7.8. MINOR CHANGE TO OPERATIONAL WORKS AND MATERIAL CHANGE OF USE (14 MURPHY STREET DRIVEWAY ALIGNMENT)

REPORT AUTHOR	Acting Team Leader Planning
MANAGER	Manager Environment and Planning
DEPARTMENT	Environment and Planning
APPLICATION NO	OP 2024_5601/1 & MCUC4732_2022
PROPOSAL	Minor Change to Operational Works Development Permit and Material Change of Use Development Permit
APPLICANT	Mr George Argyrou C/- Planning Plus PO Box 399 REDLYNCH QLD 4870
LOCATION	Road Reserve adjacent 12 Murphy Street PORT DOUGLAS and 14 Murphy Street PORT DOUGLAS
PROPERTY	LOT: 113 TYP: PTD PLN: PARCEL 2375 2094, LOT: 114 TYP: PTD PLN: 2094
PLANNING SCHEME	2018 Douglas Shire Council Planning Scheme Version 1.0
ZONING	Environmental Management Zone
LEVEL OF ASSESSMENT	Code
PROPERLY MADE DATE	1 August 2025
STATUTORY ASSESSMENT DEADLINE	30 October 2025
REFERRAL AGENCIES	N/A

TITLE
PROPOSED DRIVEWAY

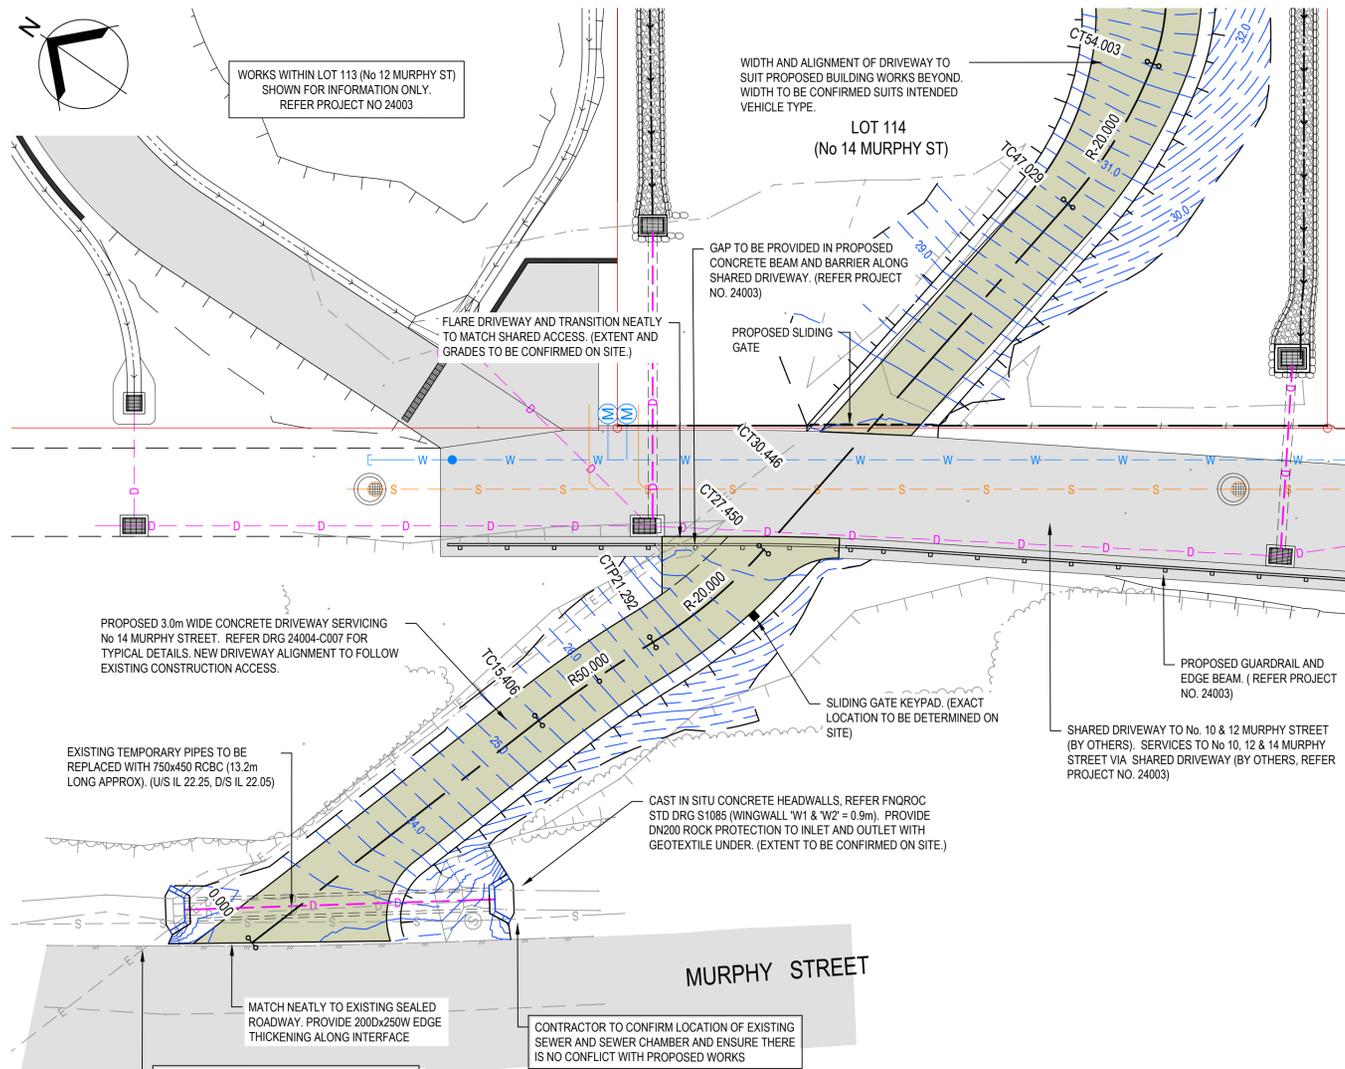
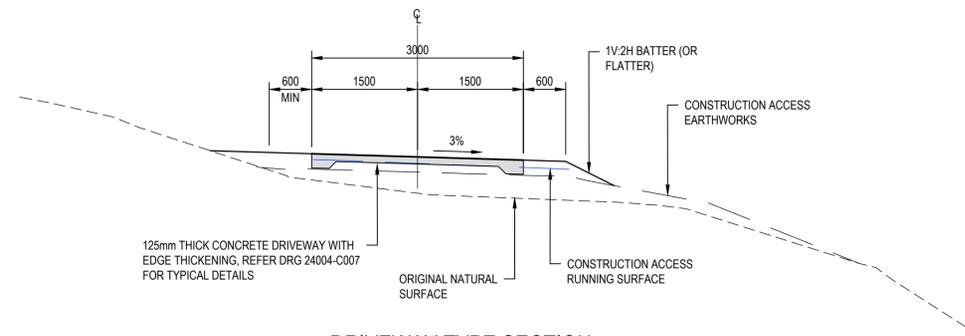
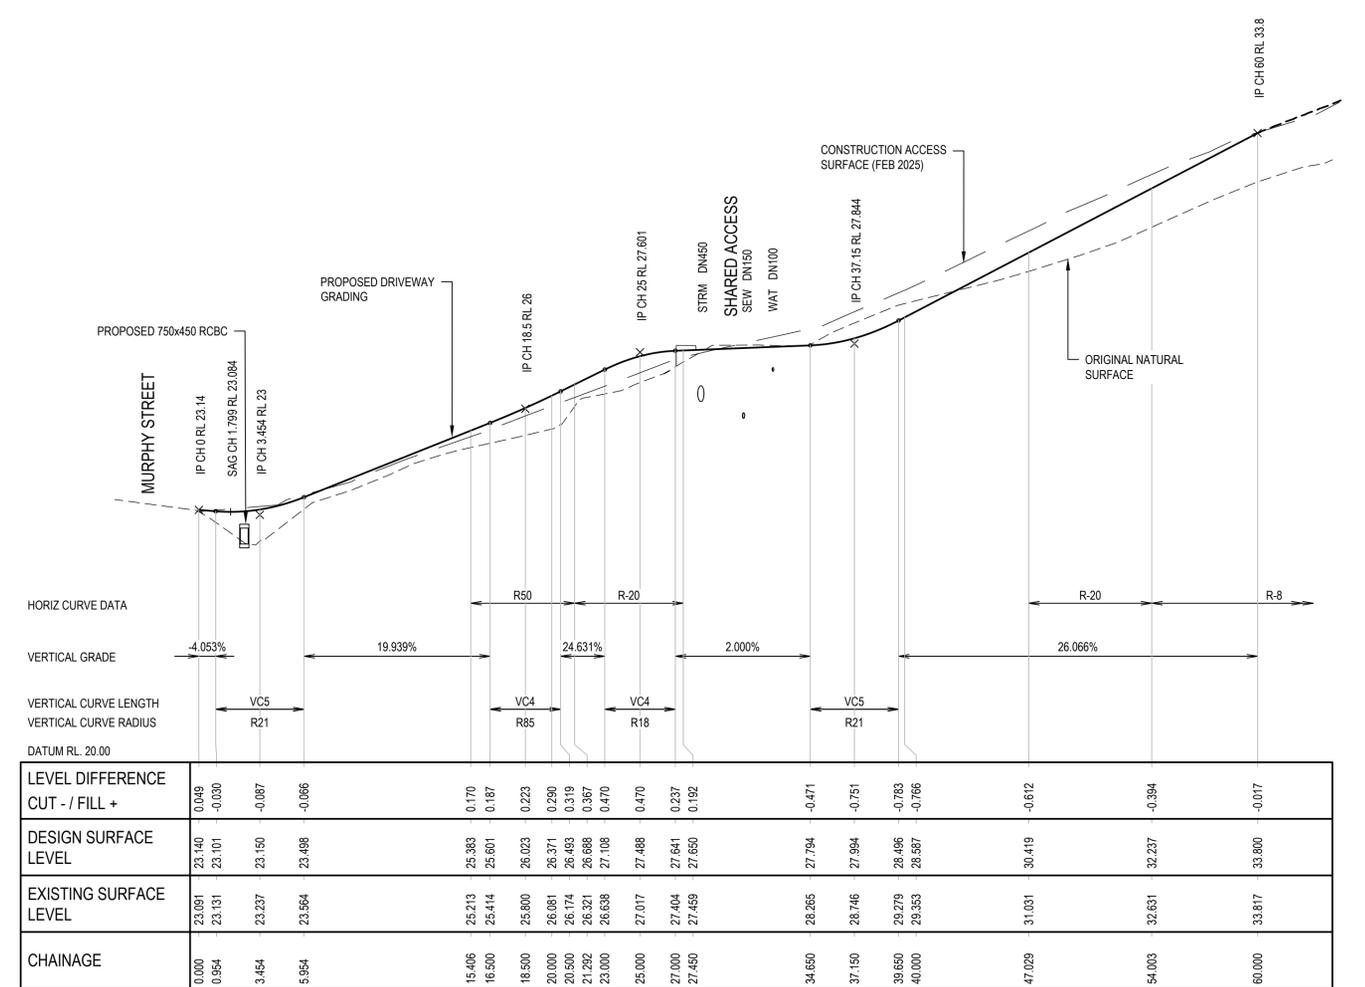
AS2890- Off Street Parking Code. The driveway design has been amended and the gradient is now somewhat acceptable and can be considered to comply with the FNQROC Development Manual which calls up AS/NZS 2890.1 1 – Off Street parking Code.

For the lower section of the driveway, the land tenure is road reserve and the Far North Queensland Regional Organisation of Councils (FNQROC) Development Manual would apply. The proposed longitudinal grade exceeds FNQROC maximum road grade of 20%.

The longitudinal grade complies with AS2890.1 maximum grade specification of 25% for private driveways as the maximum grade on the road reserve is 24.6%. Some discretion could be applied here for determining a safety factor as the location for the peak grade is also the location of the proposed keypad to open the front gate of 14 Murphy Street, which means that vehicles will stop at the intersection location of the two driveways before opening the gate and proceeding, allowing time to check for vehicles approaching.

A traffic conflict may still occur here, however the road grade represents a better outcome than the previous 28.6% design.
